Reactive Power Amendment
Proposals
BSSG 26/01/09

Amendment Proposal 1: Provision of
Reactive Power from Power Park
Modules and all Large Power Stations

Amendment Proposal 2: Recognition
of Distribution Network Imposed
Restriction on Reactive Power

BM Unit/ CCGT

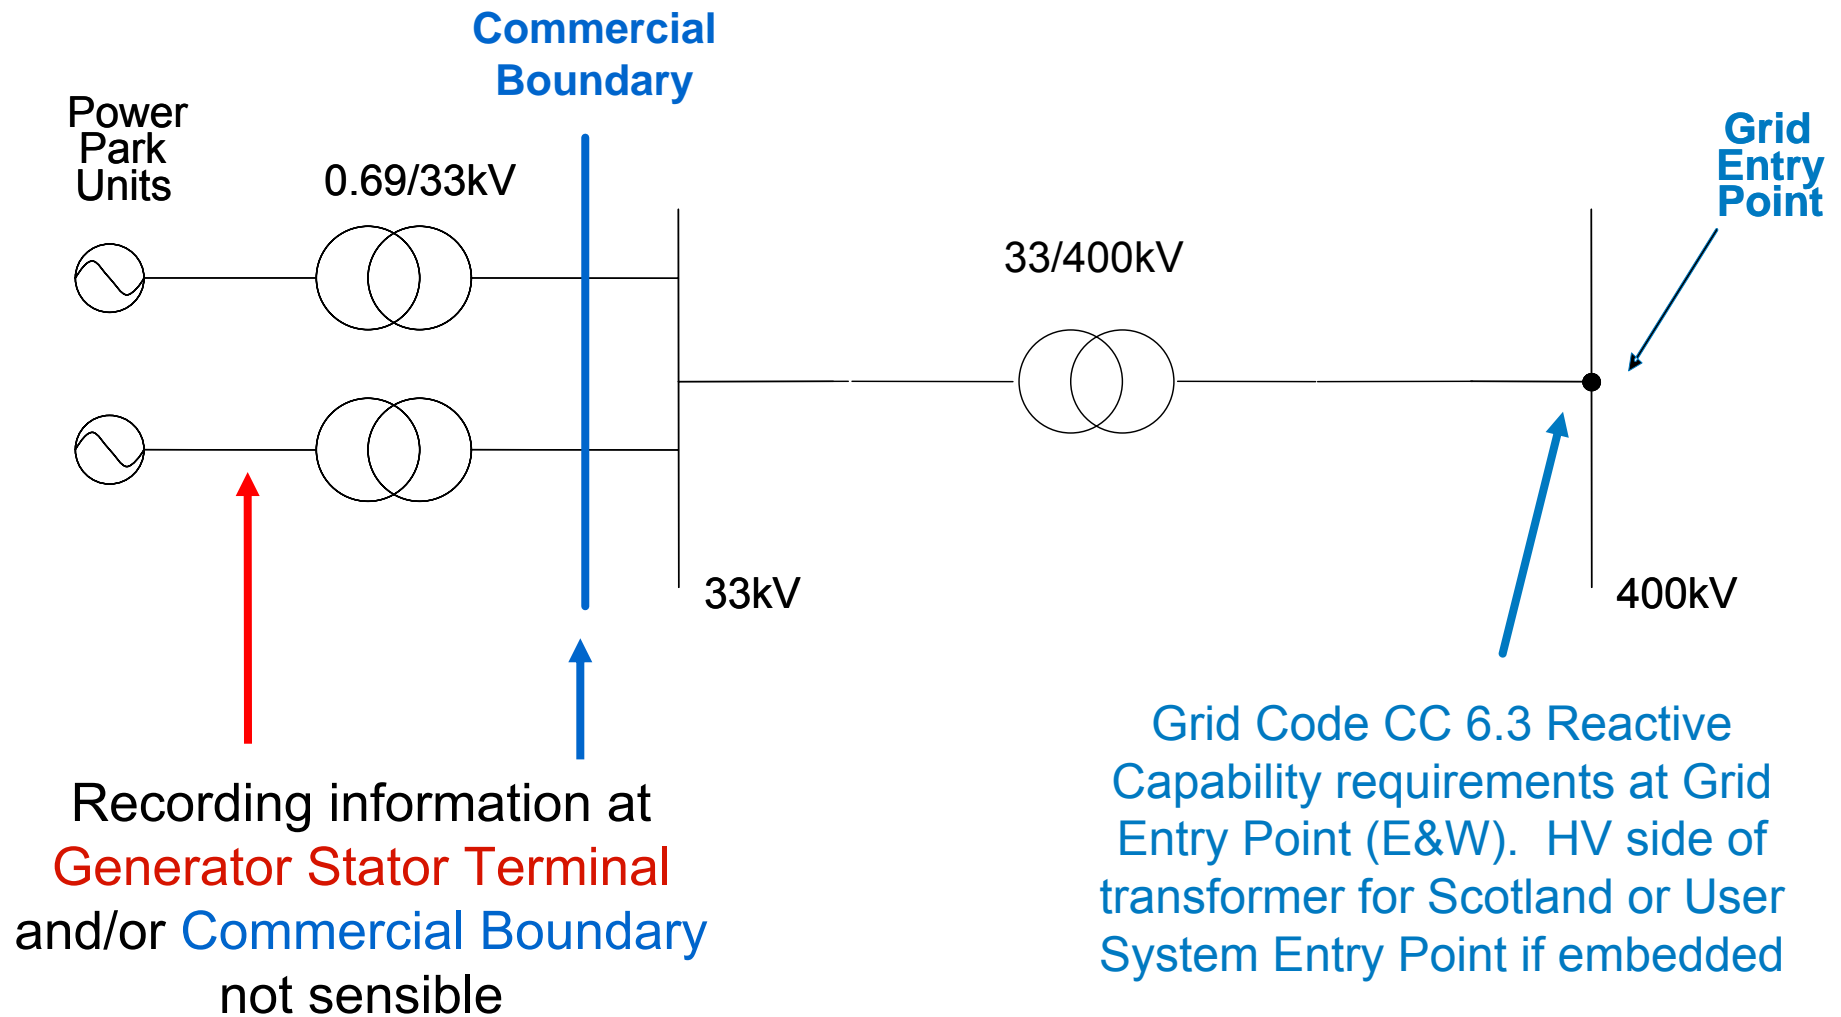
Template for MSA (CUSC Schedule 2 Exhibit 4 and associated text) record Reactive Capability at **Generator Stator Terminal** and **Commercial Boundary**

Directly Connected Wind Farm in England and Wales (using current definitions)

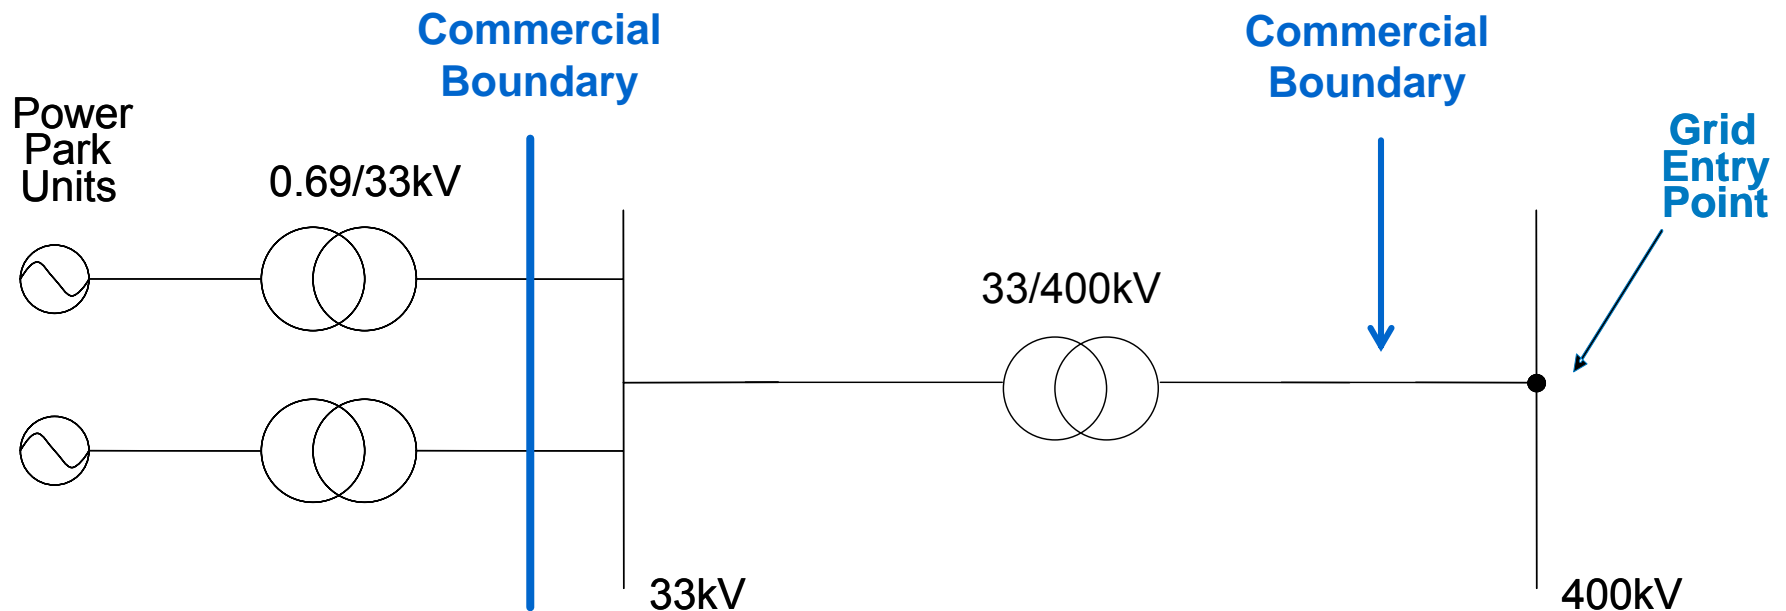
Proposed Solution – ‘Move’ the Commercial Boundary

- ◆ CUSC allows this to be achieved in the site specific MSA
- ◆ Allows for all types of connection to be accommodated

Current Definitions - Commercial Boundary

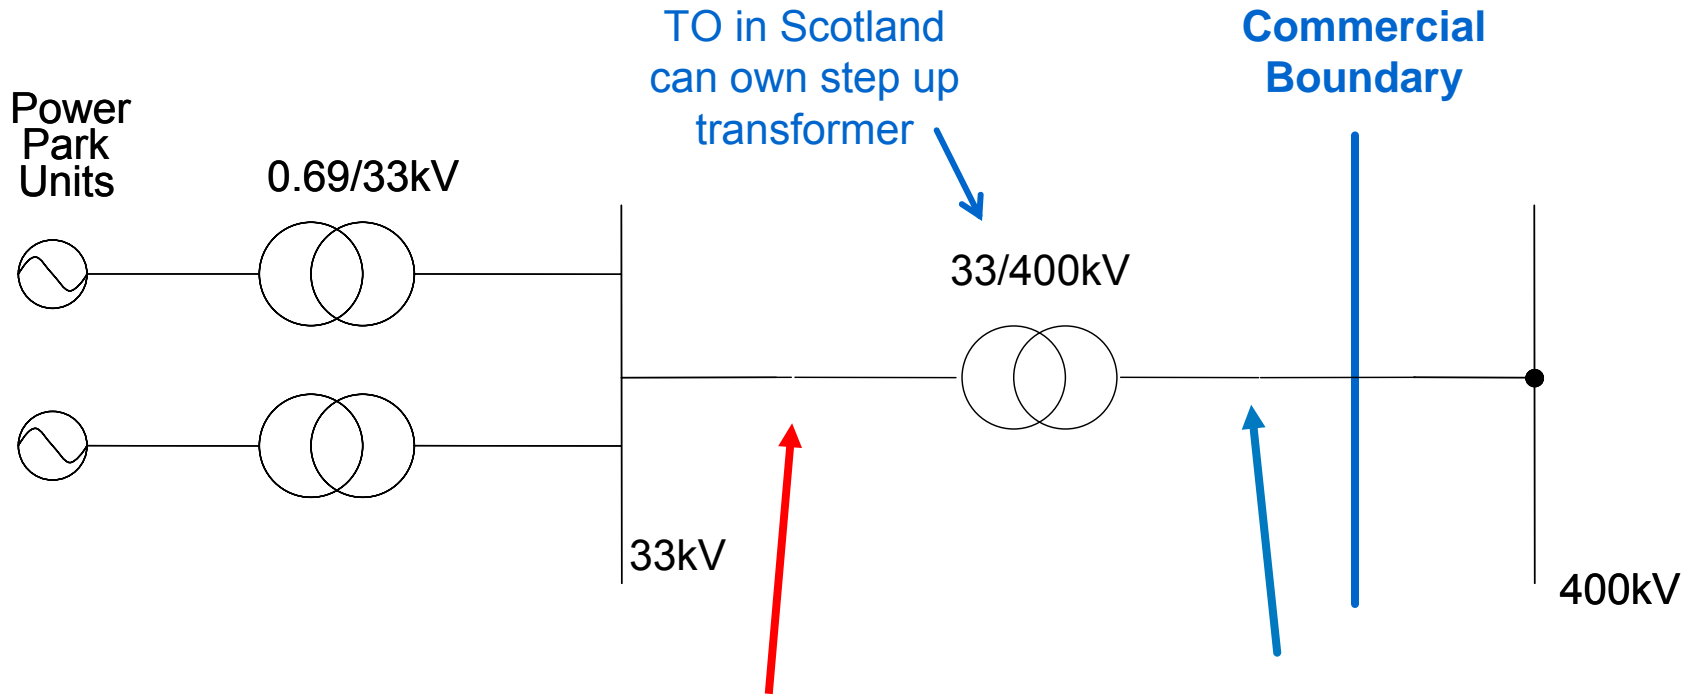
“(unless otherwise defined in the relevant MSA), the commercial boundary between either The Company or a Public Distribution System Operator (as the case may be) and the User at the higher voltage terminal of the generator step-up transformer;” CUSC Section 11

- ◆ Not sensible to uniquely define the Commercial Boundary for Power Parks in CUSC
- ➔ Proposed solution - use the individual MSAs to document where the Commercial Boundary will be (normally it will be at the Grid Entry Point or User System Entry Point for embedded)
